**APPEAL UNDER SECTION 47(2) OF THE TOWN AND COUNTRY PLANNING (SCOTLAND) ACT
1997 BY DART ENERGY (FORTH VALLEY) LTD CONCERNING COAL BED METHANE
PRODUCTION, INCLUDING DRILLING, WELL SITE ESTABLISHMENT AT 14 LOCATIONS AND
ASSOCIATED INFRASTRUCTURE AT LETHAM MOSS, FALKIRK, AND POWDRAKE ROAD, NEAR
AIRTH, PLEAN**

(REFERENCES PPA-240-2032 AND PPA-390-2029)

REBUTTAL BY PROFESSOR DAVID K. SMYTHE

CONCERNED COMMUNITIES OF FALKIRK

Fig. 1. Dart seismic database in relation to the PDA and surface-mapped faults.

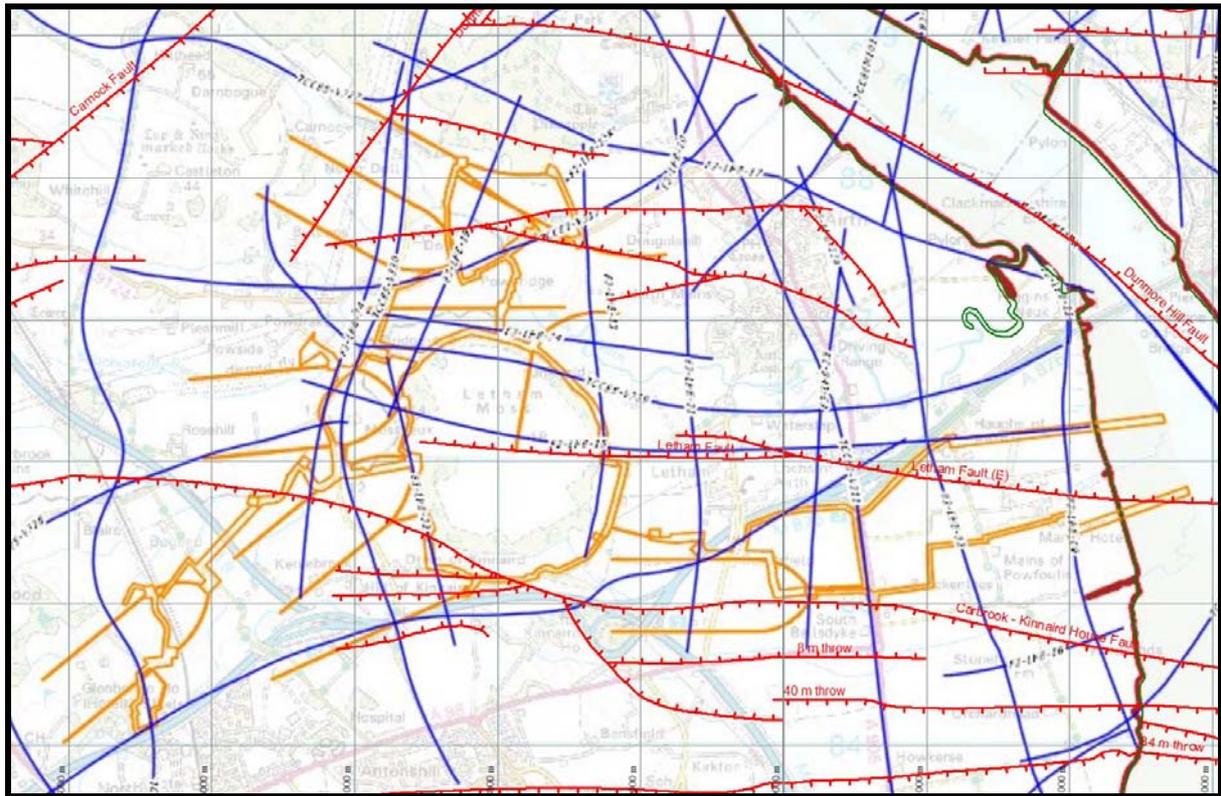
2.1.7 Figure 1 shows that the linear density of faults at the surface is greater than the density of seismic lines. Given that we need to be able to characterise how these faults behave at depth - how one merges into another; how they grow in amplitude and die out laterally; their shape and genesis (strike-slip, normal, growth) and so on - the linear density of the existing blue grid is several times too sparse for the purpose.

2.1.8 For example, the whole SW corner of the proposed development originating at Airth-13 and Airth-14 is crossed by just one N-S seismic line (see figure 10 of my precognition). This is completely inadequate, given the faulting identification problem discussed in paras. 2.2.11 - 2.2.14 below.

2.1.9 At the NW corner of the PDA the three proposed laterals directed NW are controlled by two parallel N-S seismic lines - but these two are only about 130 m apart in the area of interest, so in effect count as one line. Again, this is inadequate imaging coverage.

2.1.10 An adequate 2D seismic imaging network would comprise mainly N-S lines at a 250 m spacing, with tie lines running E-W at a 500 m spacing. The N-S direction is chosen to run across the dominant E-W geological structural trend. The existing grid is of the order of five times too sparse compared to this. But even then, the presence of oblique and cross-faults shows that the structure is more complicated than simply flat layers with E-W faulting. In short, we need 3D seismic coverage, which I have previously advocated.

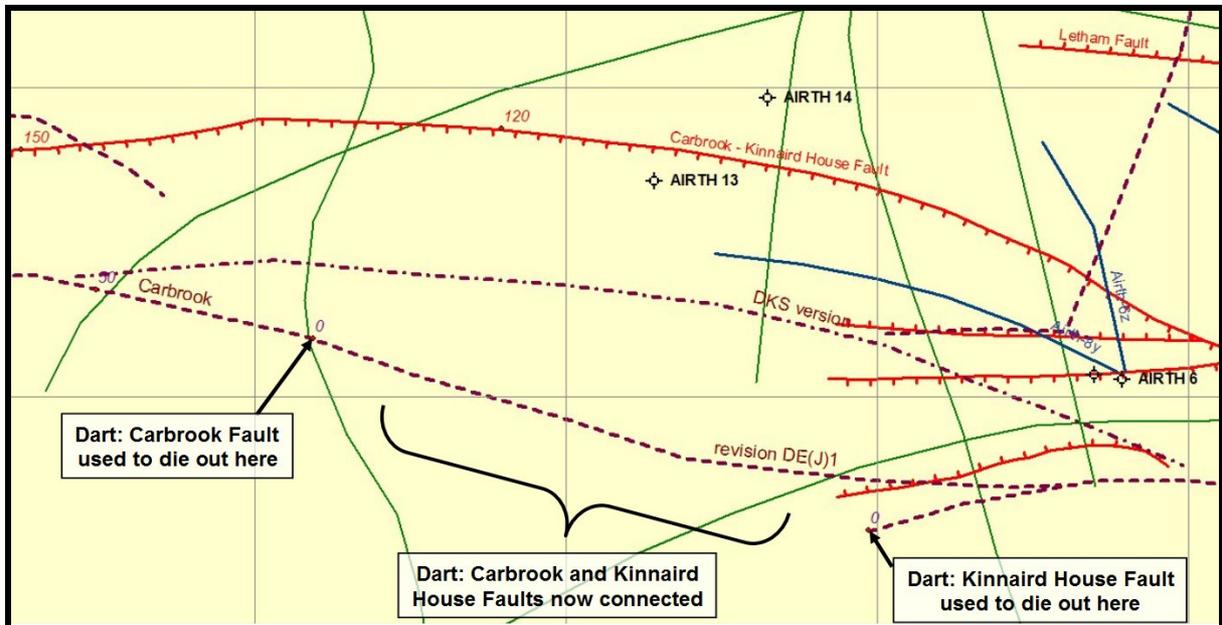
2.2.12 Now Dart has revised its interpretation, with Mr Goold presenting the two-part map dated 30 January 2014. The problem is illustrated in Figure 2, which covers the same area as my precognition figure 10. The surface location of the fault, as mapped by the BGS, is shown in red, with tick-marks on the downthrown side. A spot value of throw of 120 m is indicated in the centre, estimated easily by the considerable apparent lateral displacement of surface outcrops. But Dart's G20 interpretation showed the fault dying out (0 m throw) at the two places labelled in Figure 2. The new version now has its two separate faults connected, as indicated by the bracket, and as I pointed out should be the case.

2.2.13 Although Dart's last-minute re-interpretation is an improvement, it is still a minimal alteration. It is more consistent with the seismic data to re-draw (or to draw, in my case) the subsurface trace of the fault to keep it parallel to its surface expression. I have shown this by the dash-dot line. This difference between my version and Dart's new version is not trivial, as it still implies a difference in depth to the coal horizons of perhaps 50 m in the 'zone of dispute'. So in my view Dart's latest interpretation, although a great improvement, remains seriously in error.

Fig. 3. Quaternary permeabilities in the PDA. High - dark grey; medium - mid grey; low - light grey.

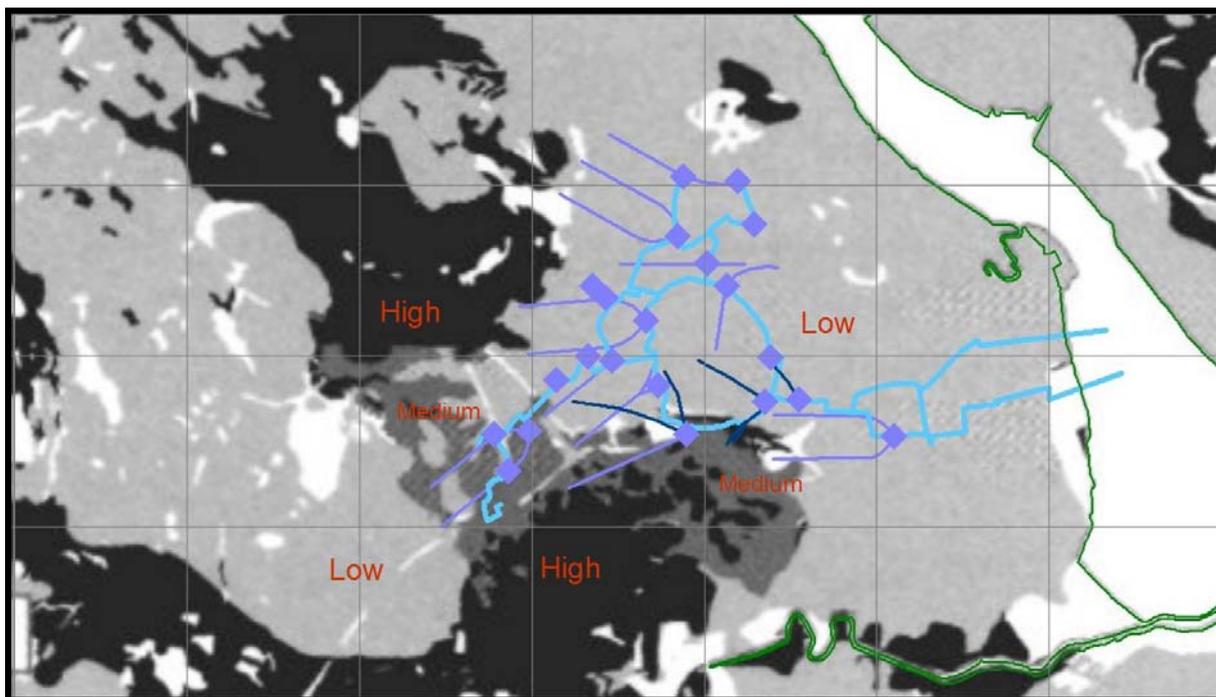
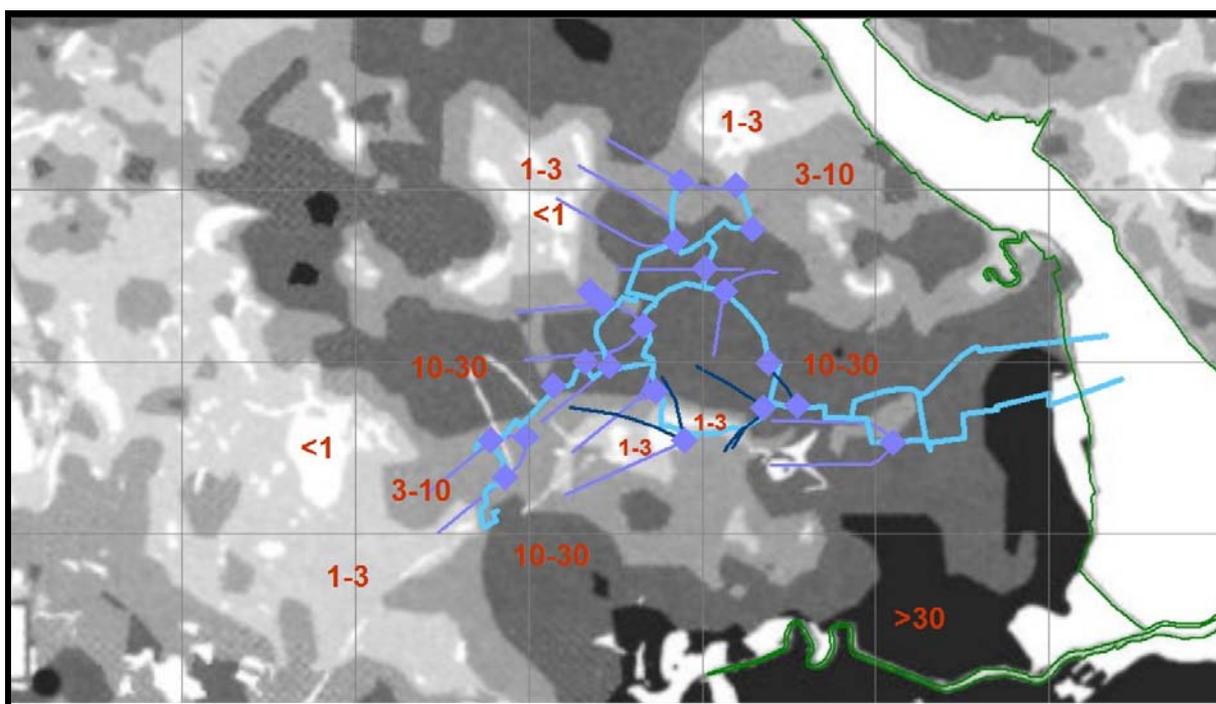
2.5.5 The thicknesses, lithologies and permeabilities of the Quaternary have been studied and mapped by the BGS within the so-called study area, including the PDA (CCoF 66: Dochartaigh *et al.* 2005). The three classes of permeability (high, medium and low) are shown in Figure 3. The Quaternary thickness is shown in Figure 4.

2.5.6 The PDA lies within zones of Quaternary with low or medium permeability (Fig. 3). The Quaternary thickness over the PDA varies from about 1 m to 30 m, with the exception of the more southerly outfall pipe to the River Forth. Approximately half of the underground works of the PDA underlie a cover of superficial clay less than 10 m thick.

2.5.7 Unindurated clays can have extremely low permeabilities, but unfortunately the range of variation in permeability of intact clays and glacial till is of the order of ten million (Hobbs *et al.* 2002). We do not know at which end of this very broad spectrum the superficial deposits in question lie. But for the implied purpose of protecting receptors from possible upward flow through bedrock faults, the known thickness of Quaternary, of the order of 10 m, is completely inadequate as a protective layer, even if it is of low permeability. In conclusion, **any upward flow along faults or other natural geological features will not be stopped by the superficial cover.**

Figure 5. Epicentres of Alloa and South Alloa earthquakes (red circles) recorded between 1970 and the present. Faults at the surface are shown in red, with tick marks on the downthrown side. The proposed development is shown in shades of blue.

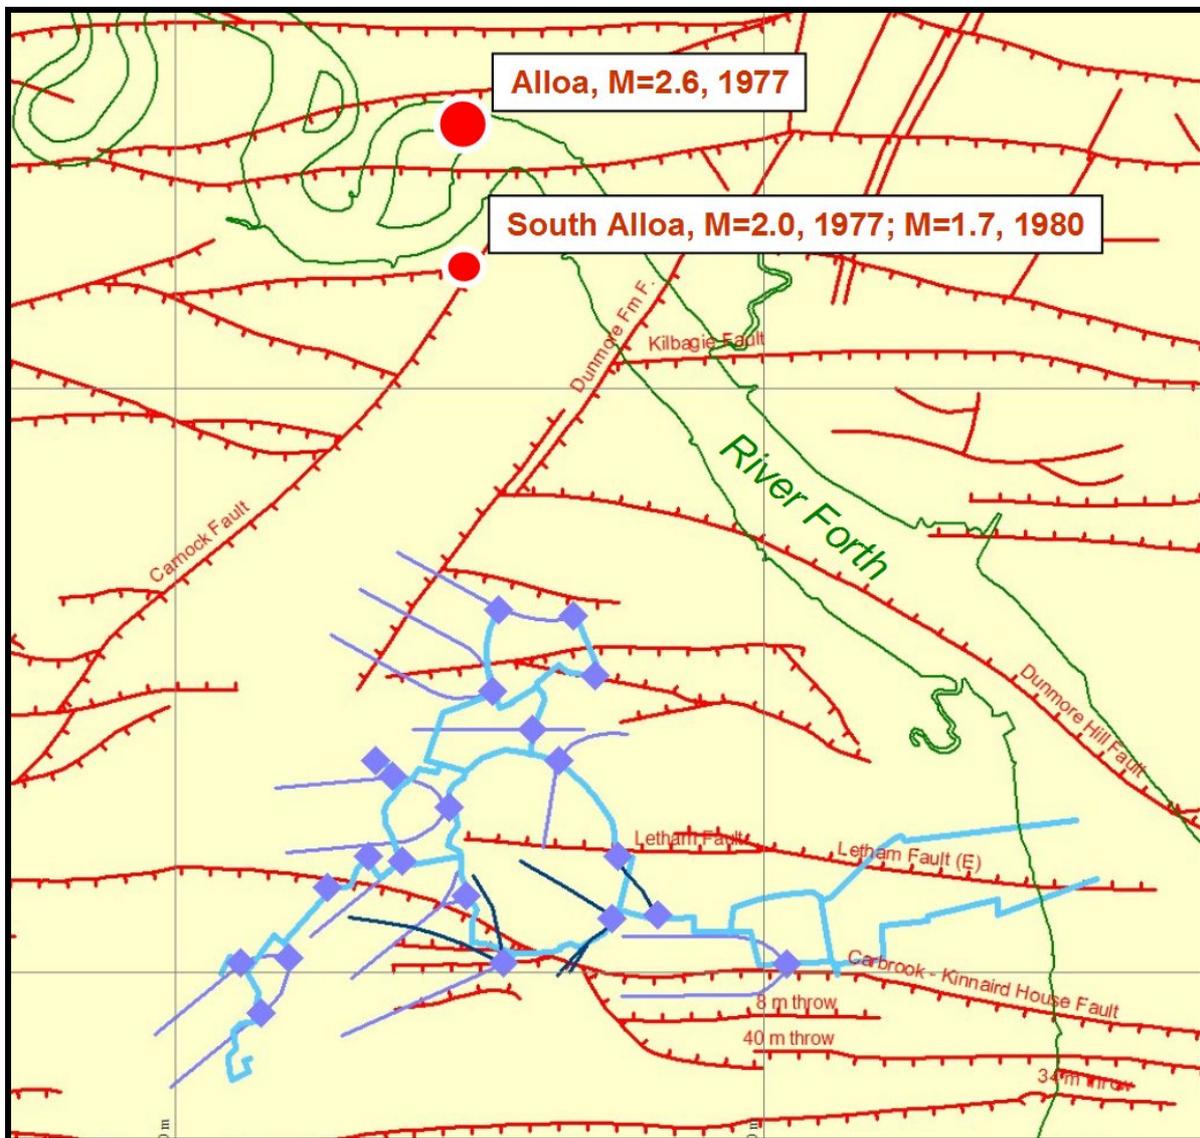
2.9.9 The Alloa earthquake, of 2.6 M_L , occurred on 3 June 1977. Its epicentre is in the River Forth (so, strictly speaking, it is outwith the PEDL133 licence area which excludes the river), and its nominal depth is zero; that means it was very shallow, but that its depth could not be calculated. It was probably caused by slip on one of the east-west faults shown in Figure 1. The coincident epicentres of the two South Alloa earthquakes appear to lie on the Carnock Fault.

2.9.10 The three earthquake epicentres are only about 5 km from the centre of the Appellant's proposed development area (PDA). **Therefore there is a clear possibility that earthquakes may occur within the PDA, and could even be triggered by drilling or dewatering.** Surface damage resulting from any such earthquake, with a maximum magnitude of less than 3.0, will be negligible, but the underground displacement and distortion could have a significant effect on the boreholes, just as the experience of Cuadrilla near Blackpool has demonstrated. If the energy released by an earthquake of magnitude 2.3 can partially flatten a steel tube, it could feasibly completely crush and close up sections of open (unlined) horizontal boreholes within fissile coal seams. This in turn could lead to disruption or blockages in the dewatering process, with consequent potential upward flux of fugitive methane. This last eventuality has been pointed out in the AMEC precognition (para. 2.3.13).

2.9.12 It is possible that the upper crust of the PDA is in a state of critical stress, as it is in Lancashire. Let us consider the simplified example of a pre-existing E-W fault, dipping north or south at 45° (this angle is a good approximation to the actual dip of the major faults). At shallow depths, less than about 300 m or so, the N-S horizontal component of stress mentioned above will be the maximum of the three components, considered in 3D. If the fault is somehow triggered, at this shallow depth, the slip will be in a reverse ('thrust') sense. But at deeper depths, say at the 800-900 m where drilling and dewatering is proposed, the sense of slip will be 'normal'; that is, the upper, so-called hanging-wall block, slips down relative to the lower, or footwall block.
